Model: PRIPORT PINKGOLD		Date: 20-May-02	No: R-C238-001
Subject: PINKGOLD firmware history		Prepared by: H. Onodera, Priport Service Planning Section	
Classification: <input type="checkbox"/> Troubleshooting <input checked="" type="checkbox"/> Part information <input type="checkbox"/> Action required <input type="checkbox"/> Mechanical <input type="checkbox"/> Electrical <input type="checkbox"/> Service manual revision <input type="checkbox"/> Paper path <input type="checkbox"/> Transmit/receive <input type="checkbox"/> Retrofit information <input type="checkbox"/> Other ()			
Model Name: Ricoh JP3000/JP3800, Gestetner 5430/5428C, RexRotary 1330, nashuatec CP430, Savin 3260DNP, Standard SD370

This bulletin is to inform you of the firmware modification history of Priport PINKGOLD.

Model: PRIPORT PINKGOLD		Date: 20-May-02	No: R-C238-002
Subject: Image shift problem		Prepared by: H. Onodera, Priport Service Planning Section	
Classification:	<input checked="" type="checkbox"/> Troubleshooting <input type="checkbox"/> Part information <input type="checkbox"/> Action required <input type="checkbox"/> Mechanical <input type="checkbox"/> Electrical <input type="checkbox"/> Service manual

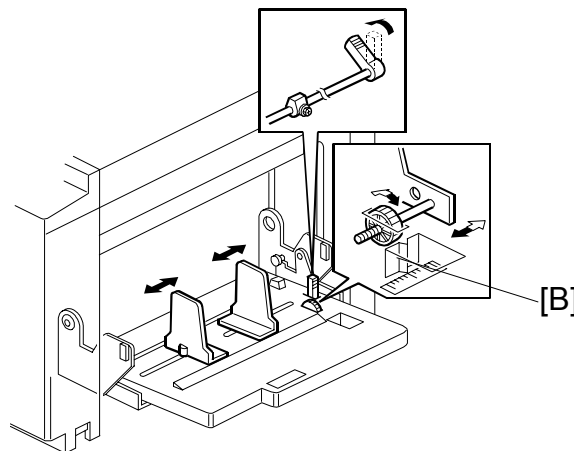
The image shifts approximately 7mm when the side fence friction pads [A] are used.

The area that the image scanning system reads is determined by the size detected in the paper tray (not by an original detection sensor). However, the machine does not adjust for the thickness of the side pads. As a result, the machine then scans an area larger than the paper's actual size, shifting the image writing start position with respect to the paper edge.

1. The width of the pads has been decreased (see MB #MC238001).
2. Main firmware suffix D has been modified so that the machine takes into account the thickness of these new pads – i.e. size detection range has been increased (see RTB #RC238001 and Table 2 below).

The basic solution is to remove the pads, since they are normally not needed (see PINKGOLD Manual, p.6-34). However if the pads are being used to prevent multi-feeds, please do one of the following:

C238A085.WMF

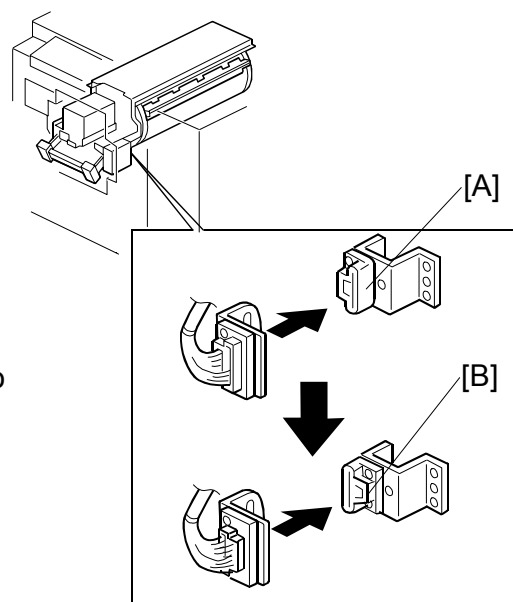
Only B4 drums can be installed on the PG B4. The direction of the connector has been changed from [A] to [B] as shown, so that the A3/A4 drums used on the PINKGOLD cannot be installed on the PG B4.

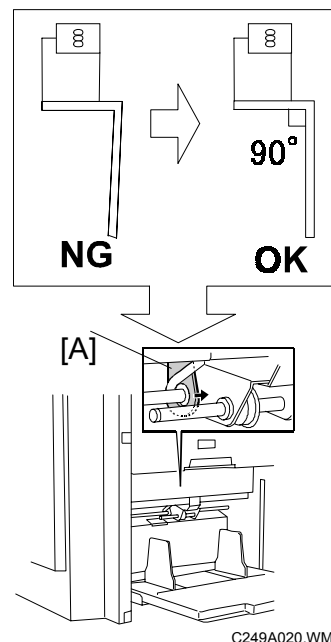
Paper non-feed ("A-jam").

A bent retainer [A] causes extra play in the bushing/roller shaft connection, which can cause the bushing to come loose.

NOTE: If this does not solve the problem, replace the Sleeve with P/N #07078105B (see MB #MC238011).

Installing the C2389000 Spacer

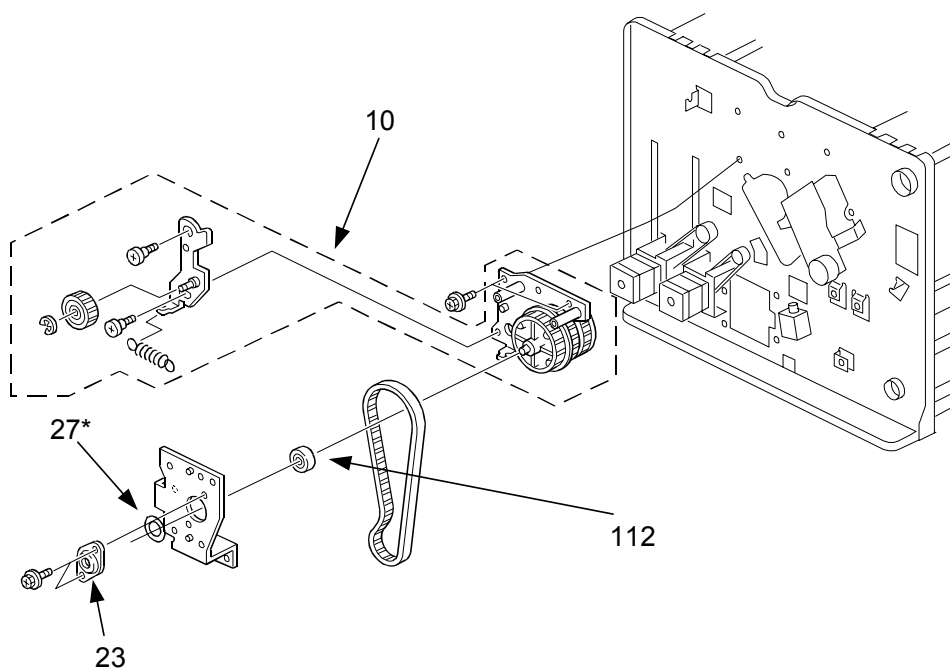
Three spacers added, as described in MB #MC238024.

1. Remove the Rear Cover.
2. Remove the Bearing Holder (#23).
3. Attach the Spacer (#27*) together with the Bearing Holder (#23).

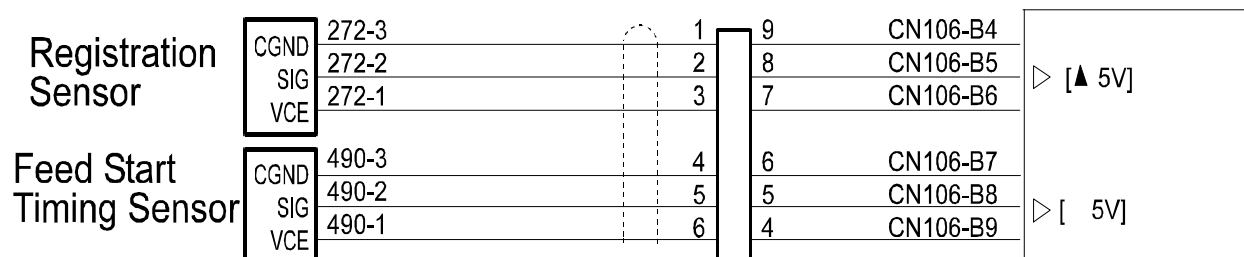
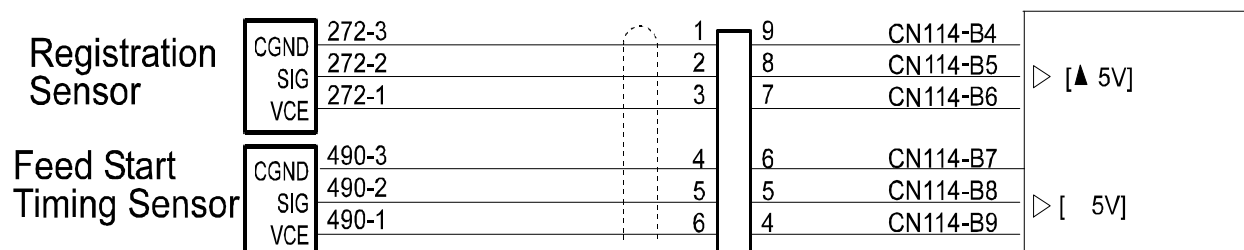
Registration and feed start timing sensors shown going to **CN 106** on the MPU.

Both sensors go to MPU **CN114**.

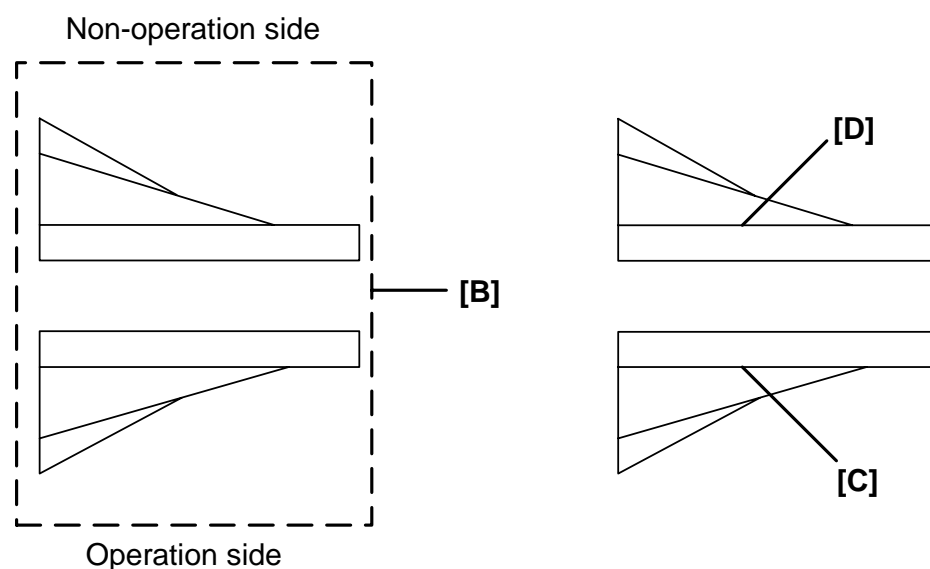
A C-jam (paper delivery jam) sometimes occurs when continuously printing many sheets.

The shapes of the air knife fan, fan bracket and delivery belt have been changed to ensure the proper paper delivery.

Note: This modification applies only to the models listed in **MB #MC238031**.

Installing the C2389002 Metal Wing Set

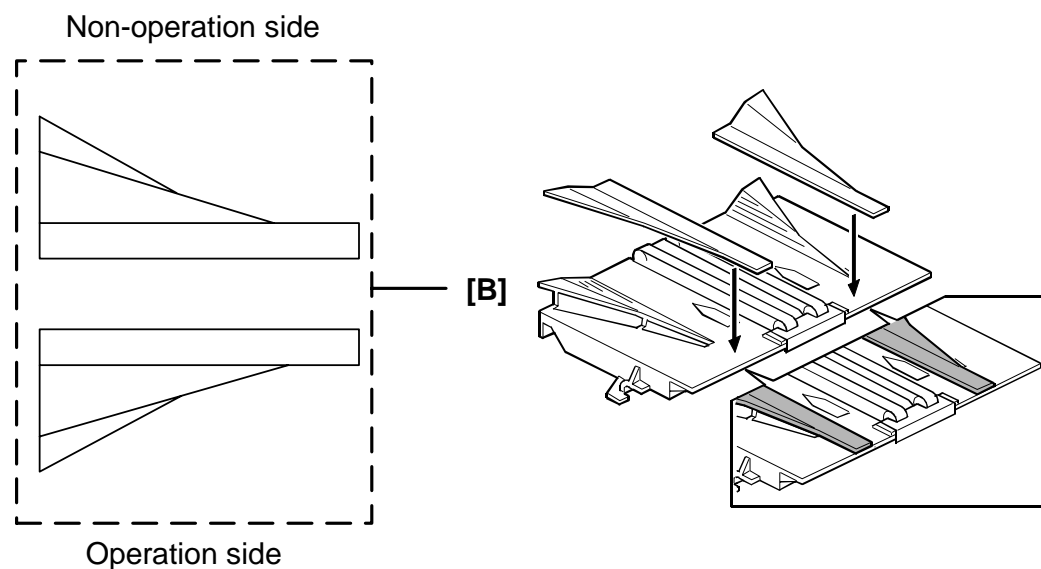
- 1) Replace the parts with the modified ones, OR
- 2) Install the metal wing set shown below.

1. Remove the paper delivery cover.
2. Remove the paper delivery unit.
3. Clean the paper delivery unit with isopropyl alcohol.
4. Peel off the double-sided tape and blue vinyl covering on the metal wings.
5. Attach the wings as shown above.

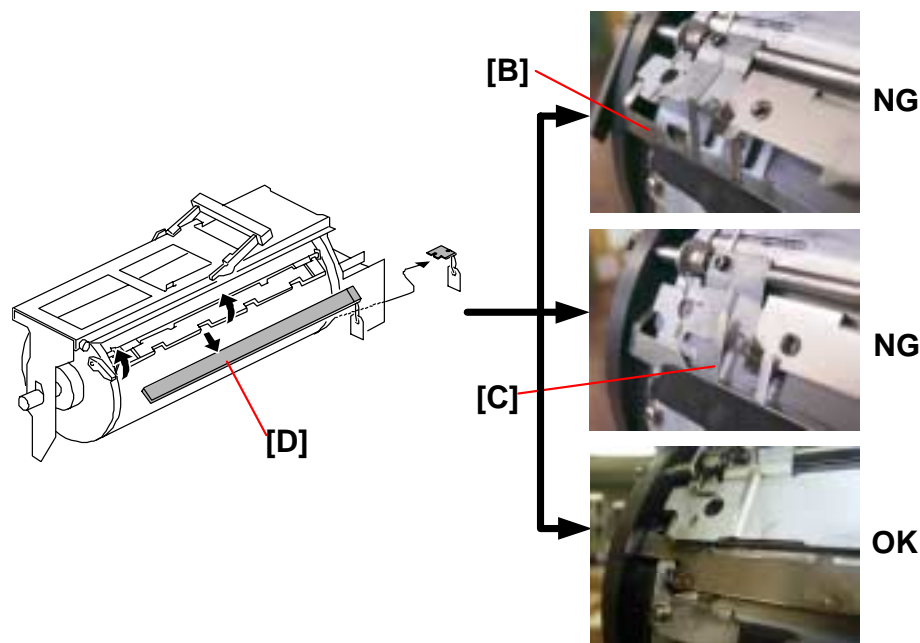
2. The master clasper [B], [C] is set in the wrong direction when the filament tape [D] is removed at machine installation.

Note: Incorrect = The clasper's lower teeth are on the outside.

- The new firmware automatically opens/closes the clasper at certain times to make sure it stays closed in the correct position.
- For details, see RTB #RC238011b.

Fig. 1: Correct

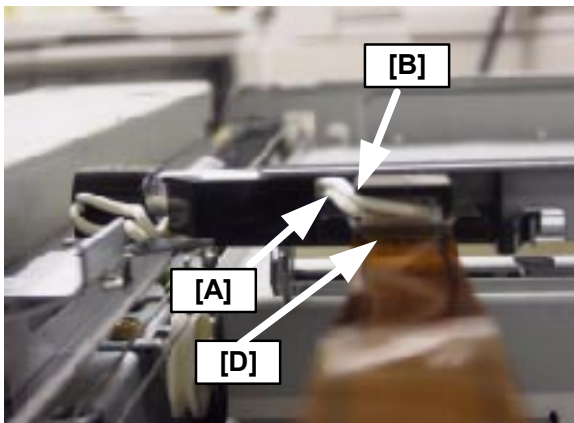
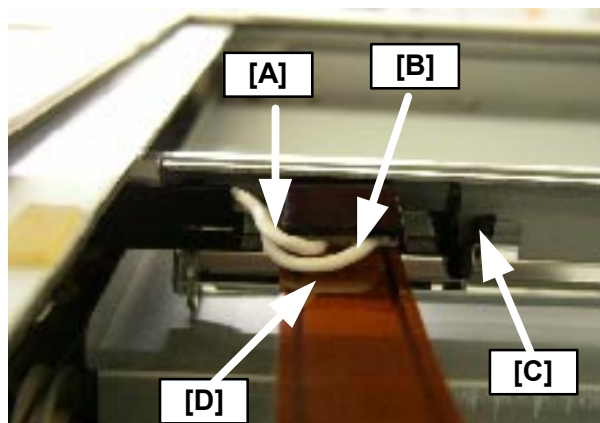
Correct (Fig. 1): Wire [A] is led under wire [B], and they are not touching the flexible cable.

- If the wires are like "Fig. 2: Incorrect", go to Step 3.
3. Turn OFF the main switch.
4. Remove the exposure glass.
5. Check the flexible cable [D].
 - If you see any damage to the outside of the flexible cable, replace it.

6. Push the pick [C] to the left to remove the Harness Guide [E] for the flexible cable.
7. Put wire [A] and wire [B] in the same position as "Figure 1: Correct."
